Z-28
(2011)

PETITION NO: Z-28

Z-28 BROOKS CHADWICK CAPITAL, LLC

Application No. z- 28
(2011)
Aug.

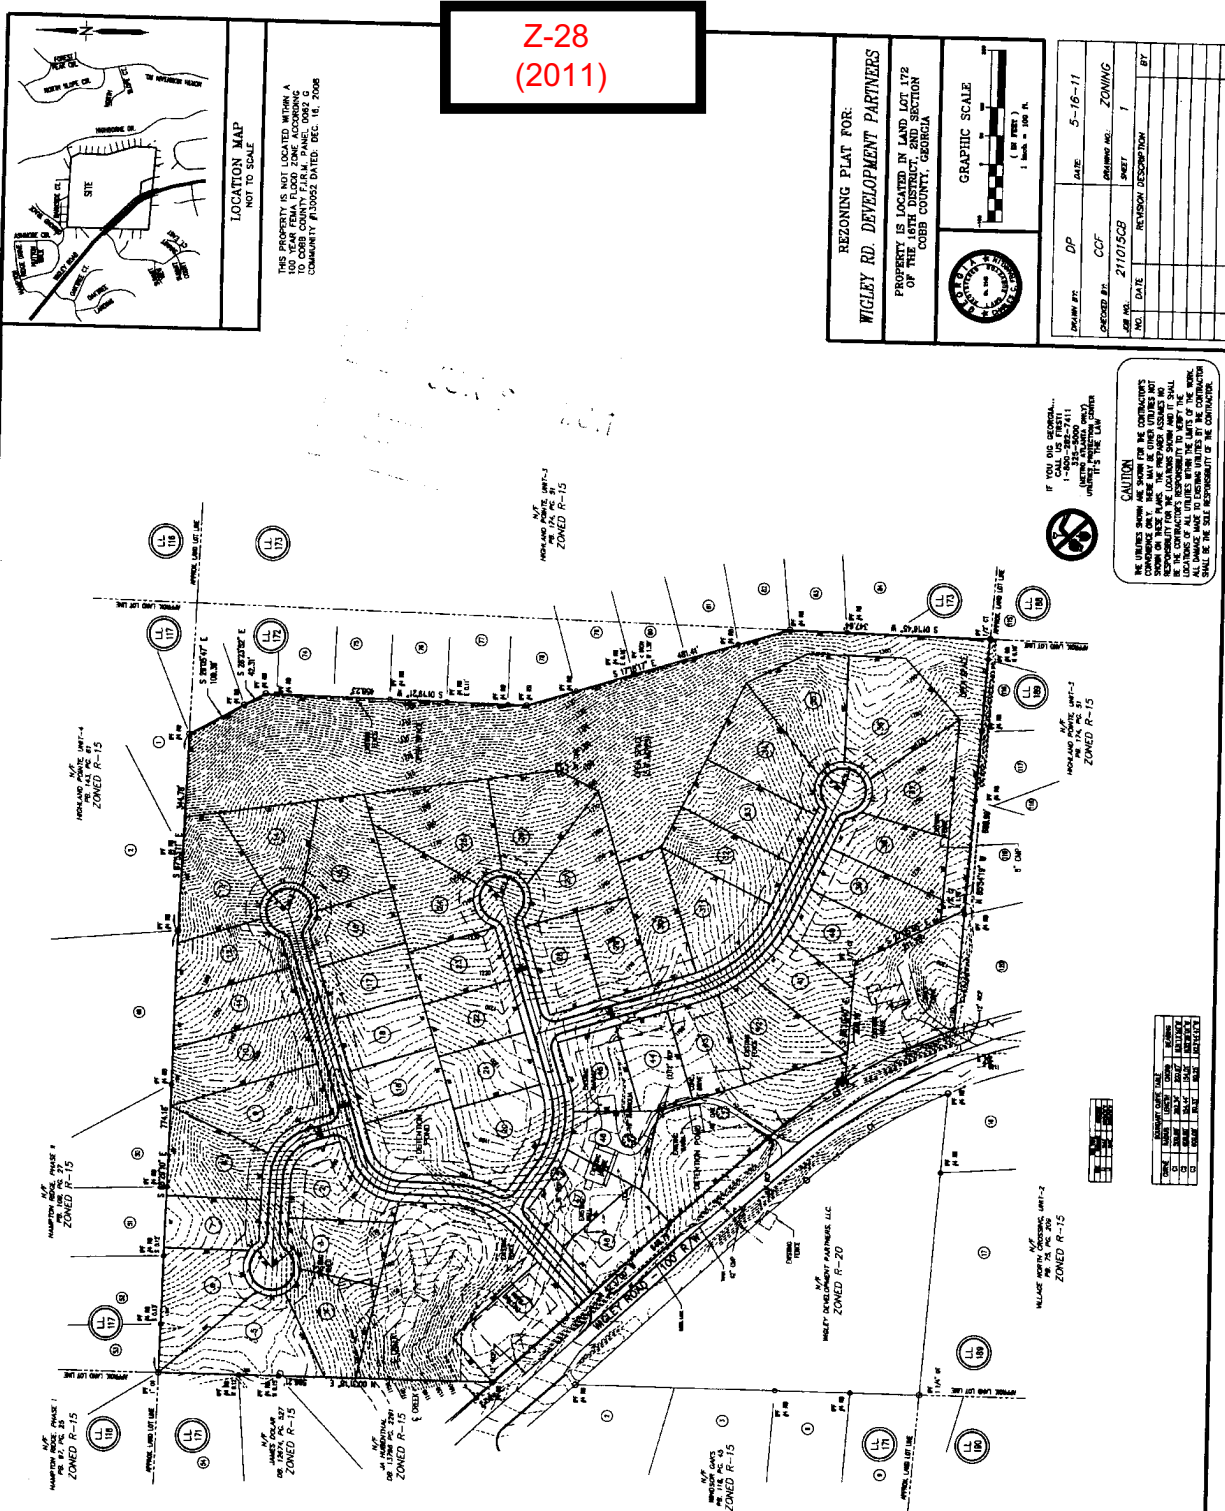
- ☒ Project engineer must evaluate the impact of increased volume of runoff generated by the proposed project on the two downstream receiving systems, including the two existing culvert capacities under Wigley Road.

1. This site is located north of Wigley Road at the base of Sweat Mountain, just below Highland Point and Hampton Ridge subdivisions. Slopes on the site range from moderate to very steep. Approximately forty percent of the overall site has slopes greater than or equal to 25%. About 10 percent (5 acres) of this area is proposed as open space. The site has two primary discharge points, one near the southwest corner of the site and one just west of the existing residential driveway.

2. Although this plan is significantly better than the previous plan proposed for this site, the small (15,000 sf) lots and 80 foot lot widths will make controlling lot-to-lot drainage difficult on this steeply sloped property. Although the surrounding parcels are zoned R-15, the topography of the site would be better suited for larger lot areas or at least minimum lot widths of 100 feet to allow room for the required drainage easements and grading to facilitate inter-lot drainage.

3. As a minimum, no grading should be allowed within the designated open space area and individual lot grading plans required for all lots significantly impacted by steep (25%) slopes. For the current layout, this would include lots 4, 8, 12 – 16, 24 – 27 and 30 – 38.

- Site plan received by the Zoning Divison on June 2, 2011, indicating front setbacks of 25 feet and larger rear setbacks of 40 feet, side setbacks of five feet with 15 feet between structures, with the District Commissioner making minor modifications;
- Water and Sewer comments and recommendations;
- Stormwater Management Division comments and recommendations; and
- DOT comments and recommendations.
